Darden Clean Energy Project (23-OPT-02)

CEC Data Request Response Set #6

August 2024

Figure 1 Oxygen Venting Rates

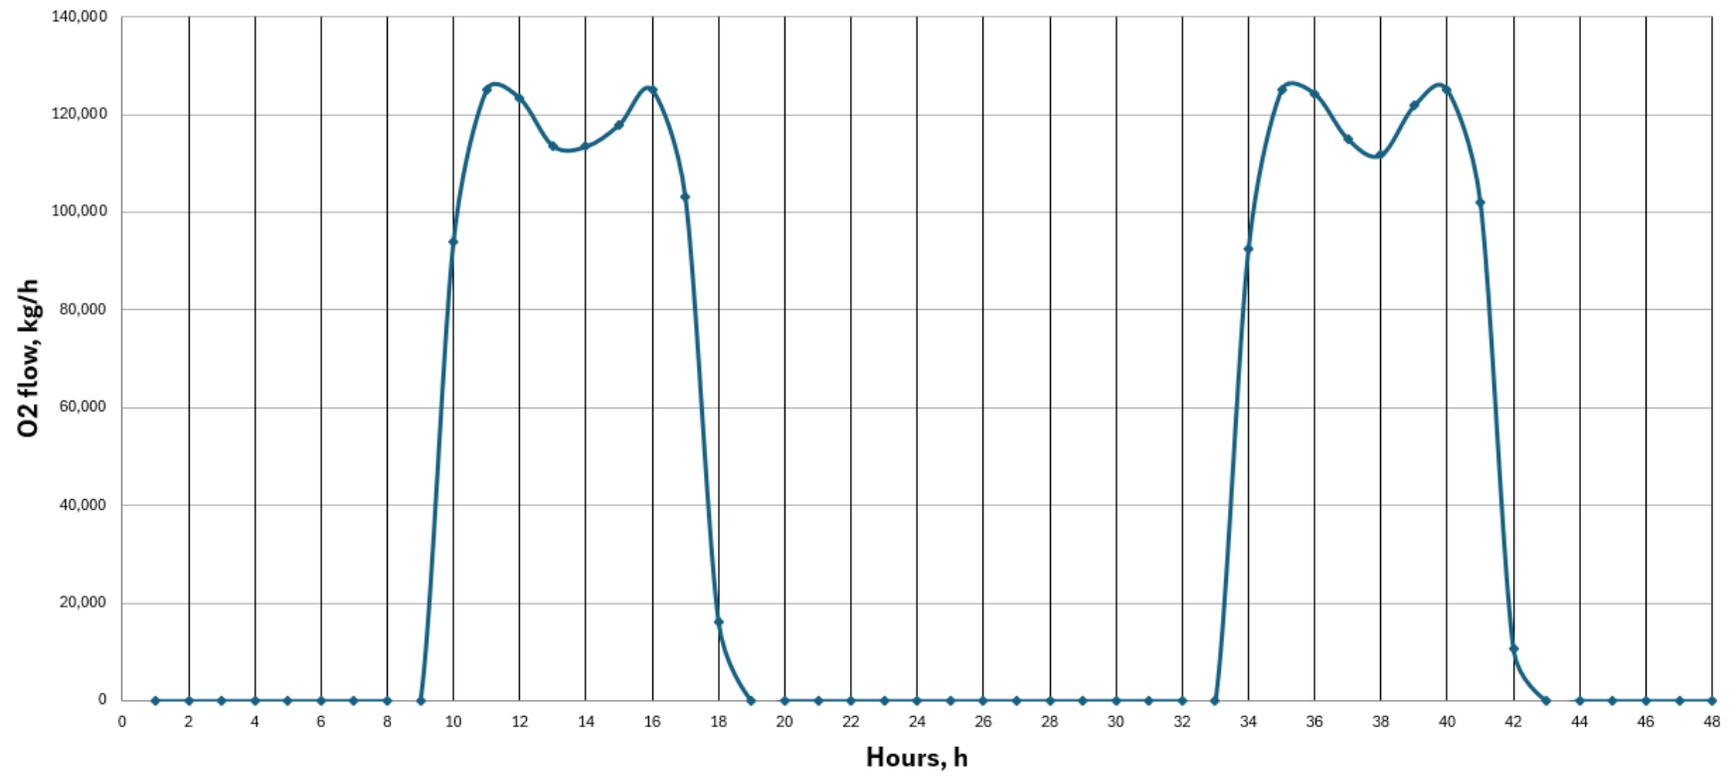
REV 1 DR PD-1: Based on the applicant's response in CEC Data Request Response Set 2 [TN 255082] to staff's DR PD-8, which stated that "Oxygen will be vented to a safe location that does not create a hazard to the natural environment," staff has additional questions. Staff is aware that under certain meteorological conditions and oxygen flow rates, the release of pure oxygen into the atmosphere is known to concentrate in some areas and has resulted in fires or explosions. Therefore, please provide additional information on the precise location(s) of these vent(s), amount of oxygen (in pounds) vented during any release, time of day of venting, elevation of the release point (in feet), and proximity (in feet) of release vents to structures, the heights of these structures, and diagrams that show the shape of these structures. Furthermore, please explain how the operation would be designed to ensure that oxygen venting occurs at a safe distance from hydrogen venting. The application, at Section 4 Engineering, indicates that the project would be designed with minimal hydrogen venting, but acknowledges hydrogen venting is expected during maintenance, start up, and shutdown (Section 4, page 4-5).

Response: Oxygen venting at the hydrogen facility will occur only when the hydrogen is produced as a by-product of the water electrolysis process. Given hydrogen will only be produced using the renewable energy from the Project, oxygen will only be vented during the day when the renewable energy is available and will generally follow the solar power profile, see Figure 1 below. Produced oxygen will be saturated with water and directed to a dedicated oxygen stack which will be located approximately 365 feet from the location of the hydrogen vent stack to ensure no mixing of vented gases. A site plan of the electrolyzer showing the location of the oxygen stack will be submitted separately with a request for confidential designation.

For the 800 MW hydrogen facility the peak oxygen venting is estimated to be a maximum of 275,552 lb/h (124,989 kg/h) when the electrolyzers are in operation. For a typical high sunshine day, the overall oxygen vented is approximately 2.4 million lbs per day (1,109 metric tonnes per day), and the average daily rate is 219,590 lb/h (99,604 kg/h for a 10-hour sunshine day).

Figure 2 Project Access Road

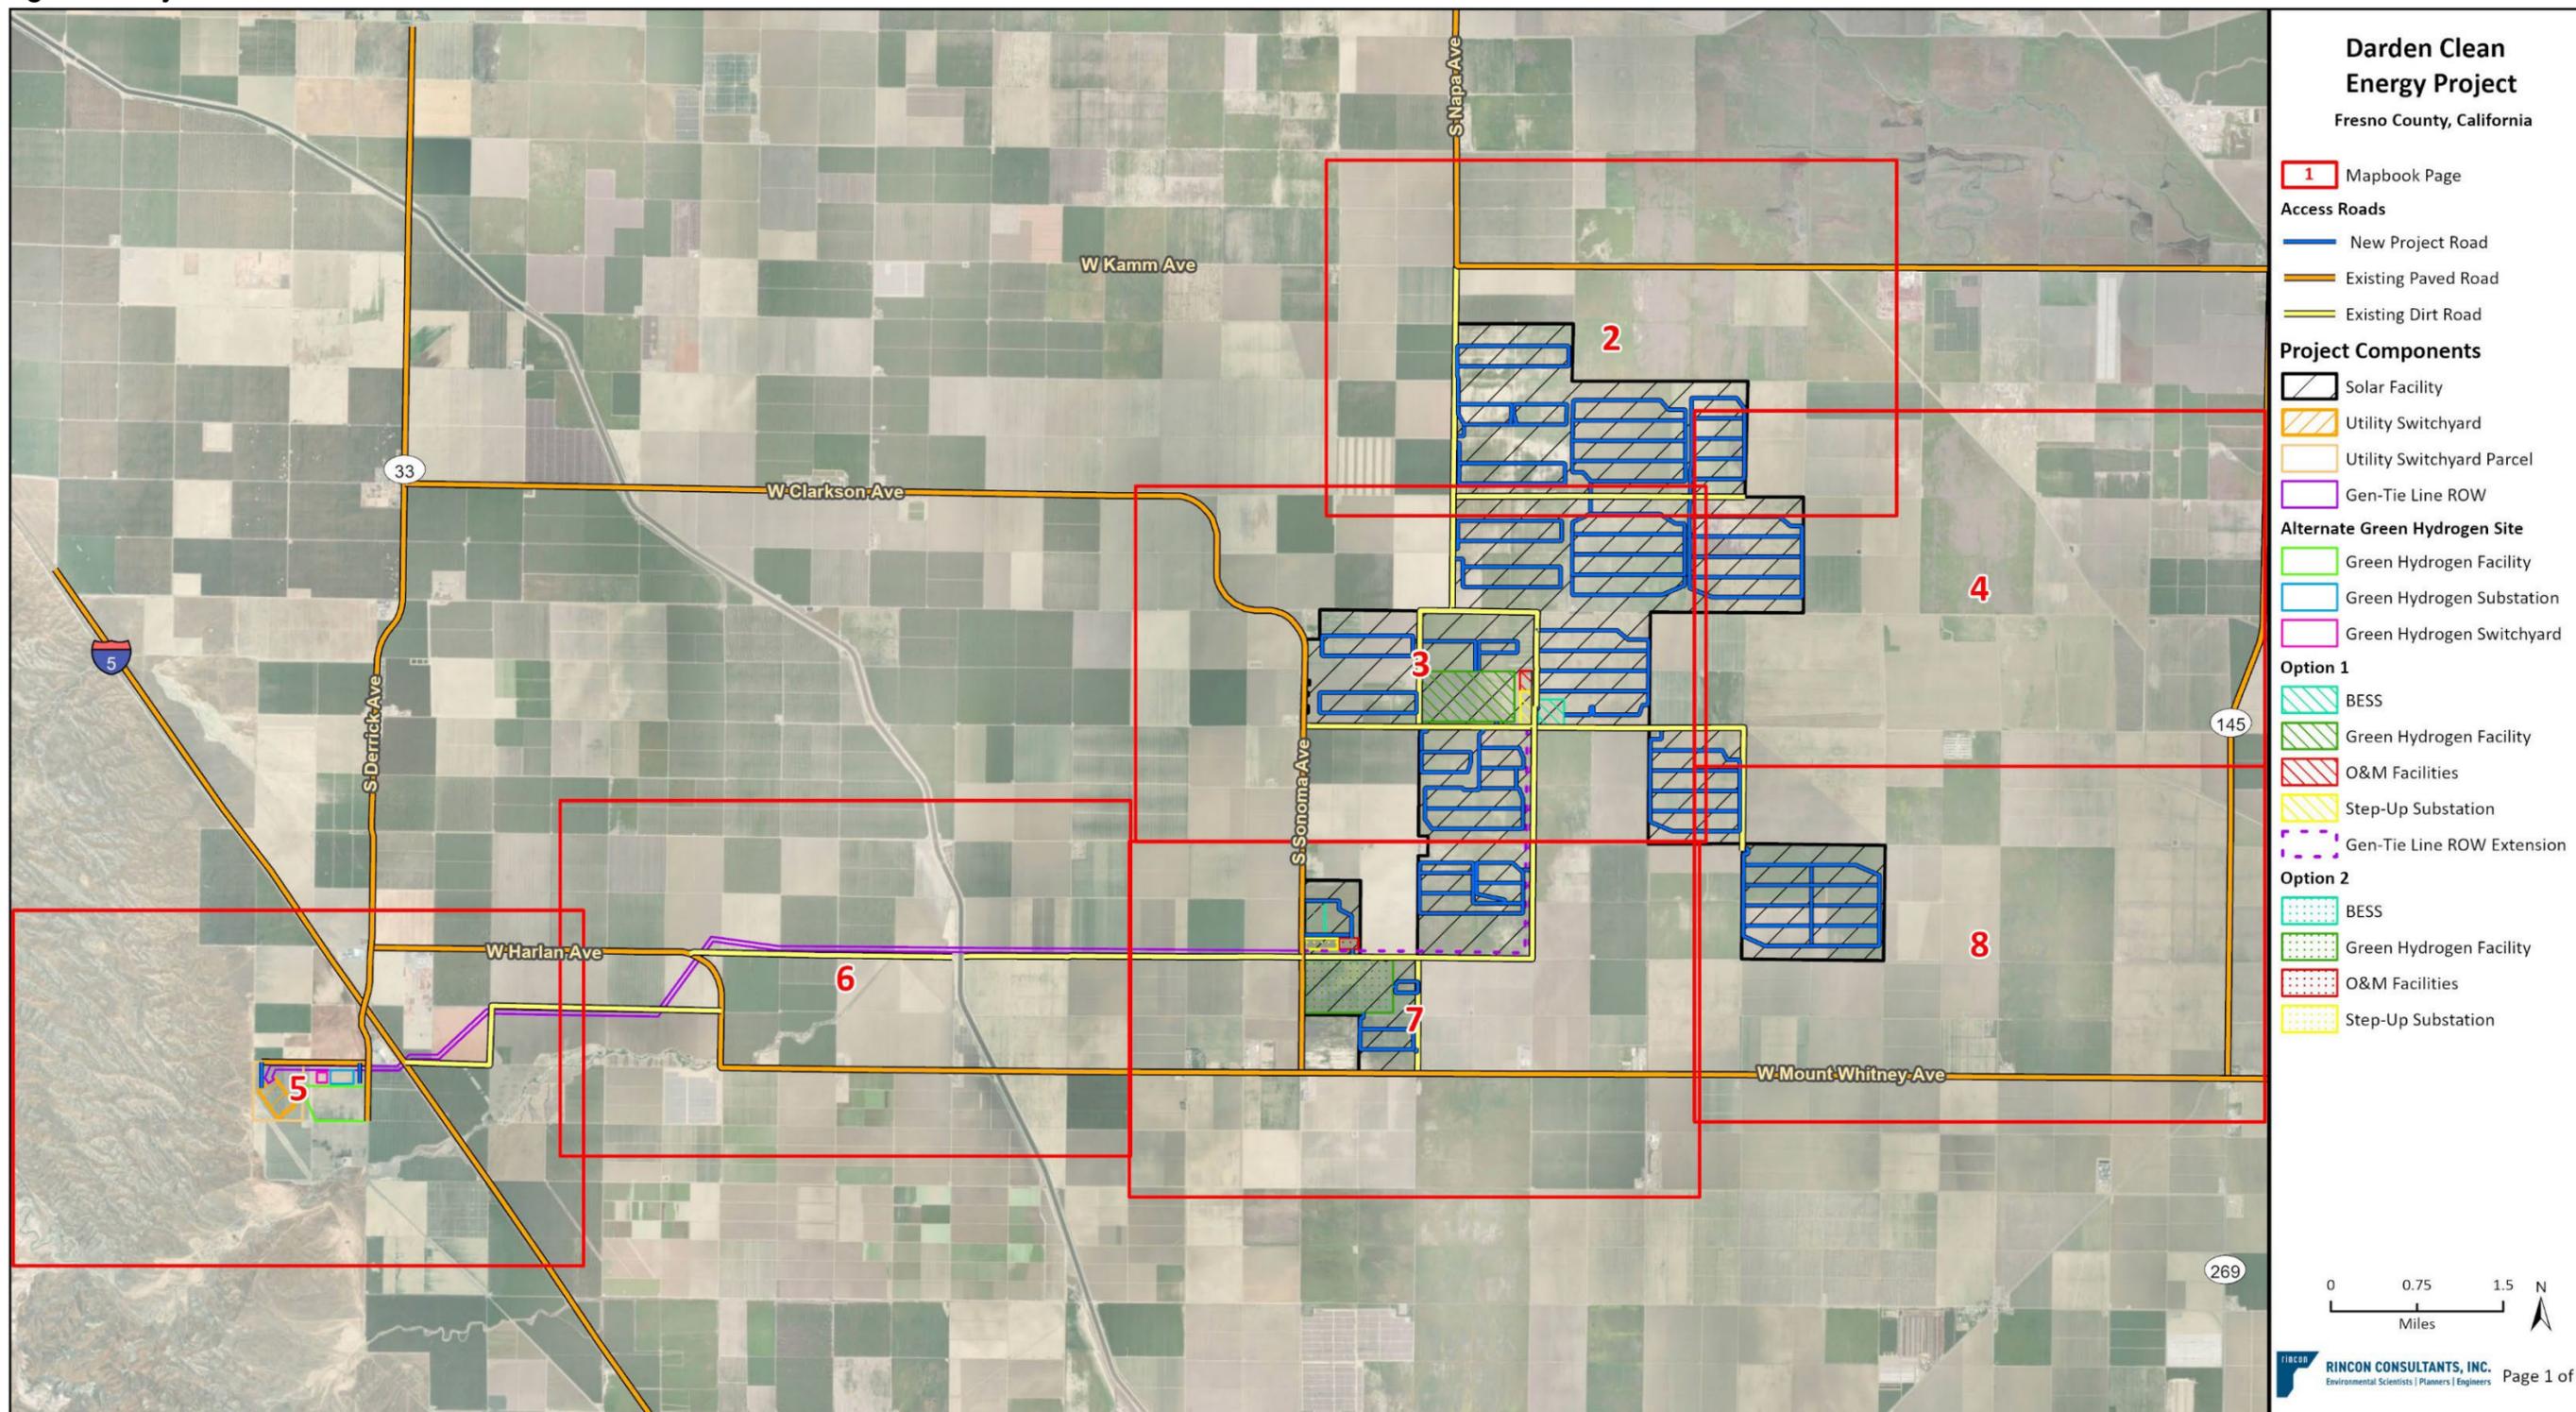
REV 1 DR TRANS-1: In the response to DR TRANS-5 in *CEC Data Request Response Set 2*, the applicant noted that road improvements are anticipated for existing access roads and will be based on current geotechnical studies and continued stages of gen-tie design and engineering. Please describe public roadways and intersections that would be temporarily or permanently altered during construction including the duration of activities. So that staff can analyze the potential impacts from improvements to access roads, provide a more detailed description of the access points for the site during construction.

REV 1 DR TRANS-2: The response in *CEC Data Request Response Set 2* to staff's DR TRANS-8 states that "access roads and access points to each project component will be finalized as detailed Project design continues; precise locations of the access roads and access points are not available at this time." That statement does not meet the application requirements of California Code of Regulations, title 20, Chapter 5, Appendix B (g)(5)(E)(ii). At least a conceptual location and configuration of access locations need to be provided at this time. Please provide a description of access points for each project component (e.g., solar facility, battery energy storage system, green hydrogen facility, step-up substation, transmission line corridor, and the PG&E utility switchyard) and clearly marked maps illustrating the location of the new roads.

Response: Project access roads are identified in Figure 2 below and consist of three different categories: existing paved roads, existing dirt roads, and new Project roads.

New Project roads that will be constructed to access the PV arrays, utility switchyard, and other Project facilities are shown in blue in Figure 2. New roads and improved existing dirt roads for PV access will receive similar treatments that will be based on soil types and site-specific conditions and could involve compacting the native base, a layer of geotextile fabric, and/or adding 6 to 16 inches of aggregate. Road improvements will be permanent and remain in place throughout the operation of the Project, and use of all of these access roads may occur throughout the duration of construction and operations.
